**CPED STAFF REPORT**  
Prepared for the City Planning Commission

CPC Agenda Item #3  
July 28, 2014  
BZZ-6639

*Property Location:* 1201 Plymouth Avenue North  
*Project Name:* Precise Products Corporation Addition  
*Prepared By:* [Mei-Ling Anderson](#), City Planner, (612) 673-5342  
*Applicant:* Darrell Freitag, Precise Products  
*Project Contact:* Todd Ofsthun, TCO Design  
*Request:* To allow an 11,520 square foot addition to an existing building.  
*Required Applications:*

## Preliminary Development Review Report

**SOUTH ELEVATION**  
 scale 1/8" = 1'-0"

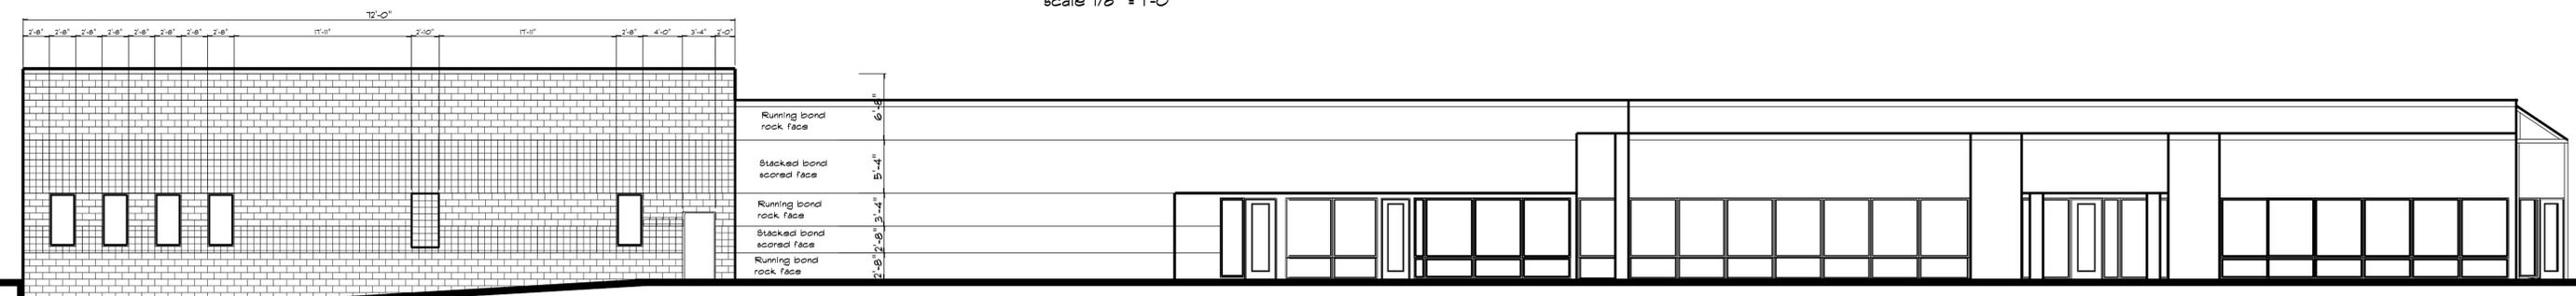
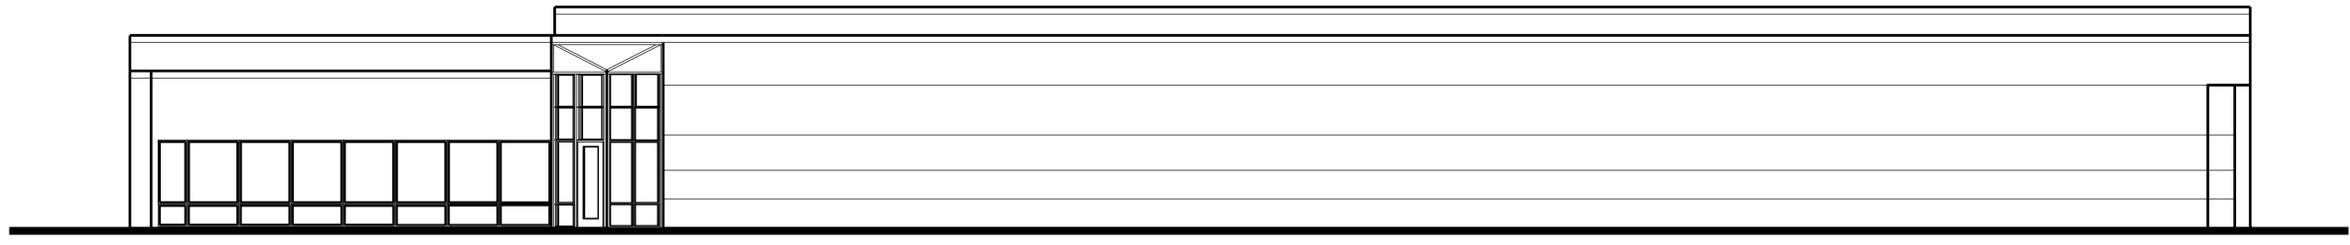
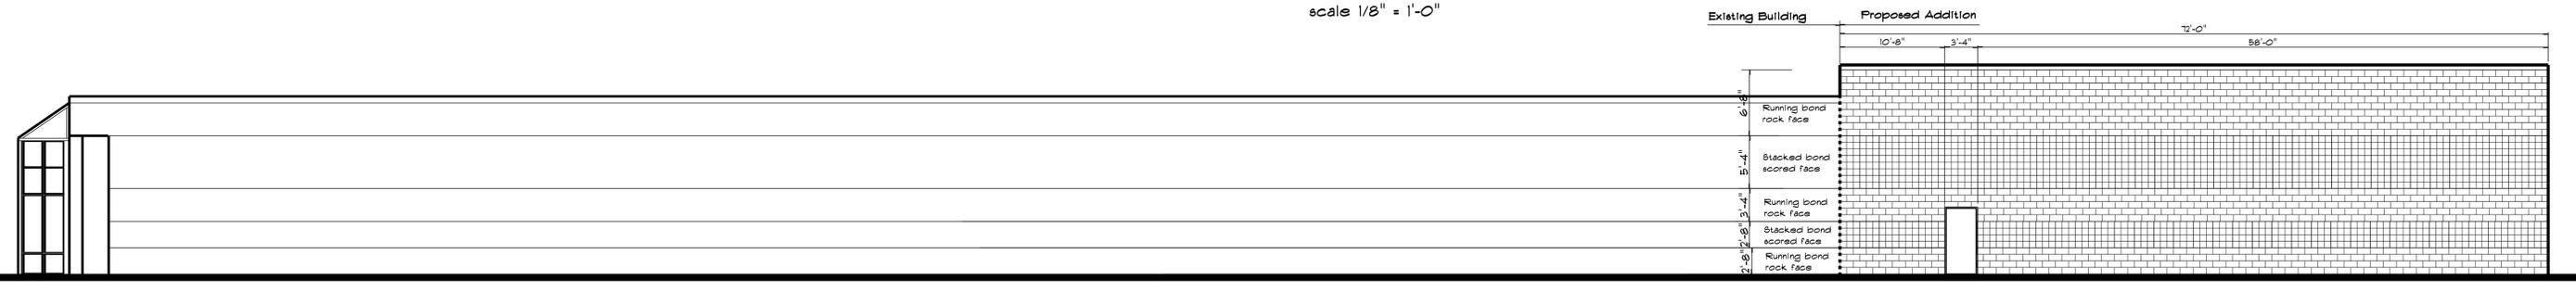
- The walls of the addition contain walls and doors to break the building into smaller identifiable sections.
- The east, west, and south elevations are subject to the blank wall standard. The west elevation, which faces the side yard of an industrial property, would have a blank wall exceeding 25 feet in width. Alternative compliance is requested for this elevation.

- All sides of the building would be compatible with and similar to each other.
- The principal entrance proposed on the south elevation does not contain features that express the importance of the entrance. Alternative compliance is requested for this standard.

- The east and south elevations face a public street as well as on-site surface parking lots and are subject to the 30 percent windows requirement. On the east elevation, the applicant is proposing five windows between two and ten feet, however, the total amount of windows on this elevation does not meet the minimum 30 percent requirement. The south elevation contains windows but they are located more than ten feet above the adjacent grade. The applicant is proposing glass block on this elevation between two and ten feet, which does not meet the minimum standard for a transparent window per the zoning code standard. The applicant is requesting alternative compliance for the minimum window requirement for ground floor non-residential uses. See **Table I**.

- **Blank walls.** The east, west, and south elevations are subject to the blank wall standard. The west elevation, which faces the side yard of an industrial property, would have a blank wall exceeding 25 feet in width. Alternative compliance is requested for this elevation. It would be practical to require compliance with this standard given that the south elevation of the building contains windows and the use that is interior to that elevation is the same as the use that is interior to the west building wall.

- **Emphasis of principal entrances.** The principal entrance proposed on the south elevation does not contain features that express the importance of the entrance.

- **Windows.** The east and south elevations face a public street as well as on-site parking areas and are subject to the 30 percent windows requirement. On the east elevation, the applicant is proposing five windows between two and ten feet, however, the total amount of windows on this elevation does not meet the minimum 30 percent requirement. The south elevation contains windows but they are located more than ten feet above the adjacent grade. The applicant is proposing glass block on this elevation between two and ten feet, which does not meet the minimum standard for a transparent window per the zoning code standard. The applicant is requesting alternative compliance for the minimum window requirement for ground floor non-residential uses for security reasons. On the south elevation, there are windows provided on the first floor above ten feet to allow light into the building on this side. The east elevation of the existing building exceeds the windows requirement and offsets the impact of the lower proportion of windows on the addition. In addition to these alternatives, staff is recommending that the applicant comply with the landscaping requirements by providing additional enhanced landscaping with seasonal interest and a variety of plant types in the required landscaped areas to enhance the delineation between public and private space. Staff is recommending that alternative compliance be granted.

3. All signs shall comply with Chapter 541 of the Zoning Code. All new signage requires a separate permit from CPED.
4. The applicant shall provide windows, recesses, or projections on the west elevation of the addition to eliminate blank walls exceeding 25 feet.

5. The applicant shall add features to the doorway facing 12<sup>th</sup> Avenue North to emphasize that it is a principal entrance.
6. The applicant shall provide a four-foot wide pedestrian walkway along the south building wall to connect the principal entrance to new on-site parking facilities.

10. Additional enhanced landscaping with seasonal interest and a variety of plant types shall be provided in the required landscaped areas as an alternative to complying with the window requirements.
